CONDITIONS OF APPROVAL:

Engineering - 2015 PUD Checklist

Prior to the issuance of a Building Permit, a revised Final Plat for the adjacent Bank property (Lot 1 of First Citizens Bank of Williamson County Subdivision Plat Book 27 Page 145) shall be approved and recorded. The revised final plat shall incorporate the easements and agreements required for the 1st and Main Site Plan (COF No. 6626), including but not limited to:

48. D. Site Plan

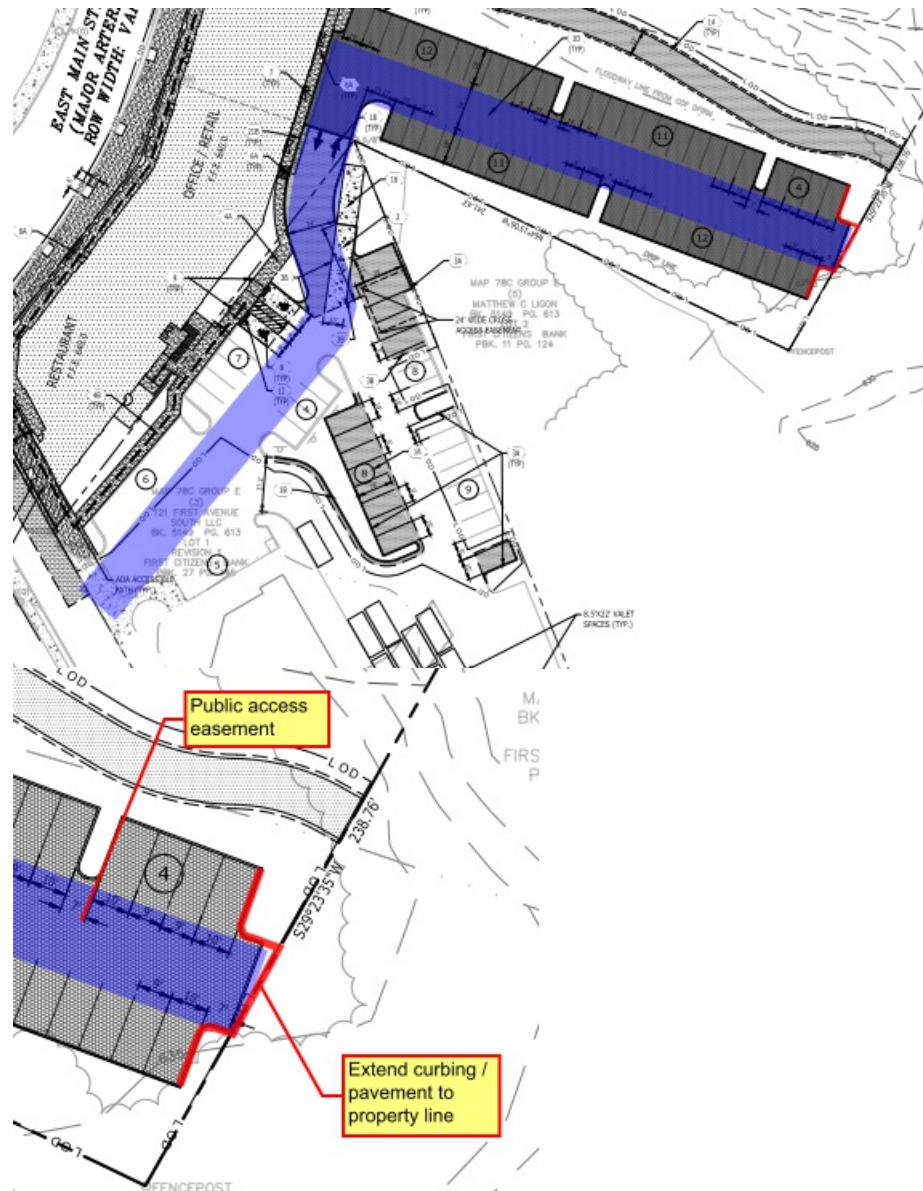
joe.marlo@franklin.tn.gov **Prior to One Stop Approval**, Applicant to execute and record the Cross Parking and Access Agreement, and the recorded reference is to be shown on the Site Plans.

126. Demolition Plan

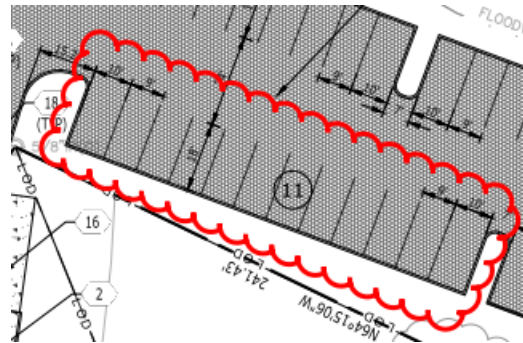
joe.marlo@franklin.tn.gov The comment is a newcomment based on newinformation shown on the drawings.

The added Demolition Plan (C1.3) now shows the existing light pole adjacent to the East Main Street Bridge as being removed.

Applicant to revise drawings as follows:

1. Call out Note 15 in plan on Sheet C1.3.
2. Show the new or relocated light pole location on the remaining Civil and Electrical sheets.
3. Show the other existing street lights along East Main Street on the Site Plan (C2.1). These appear to have been inadvertently left off this sheet.
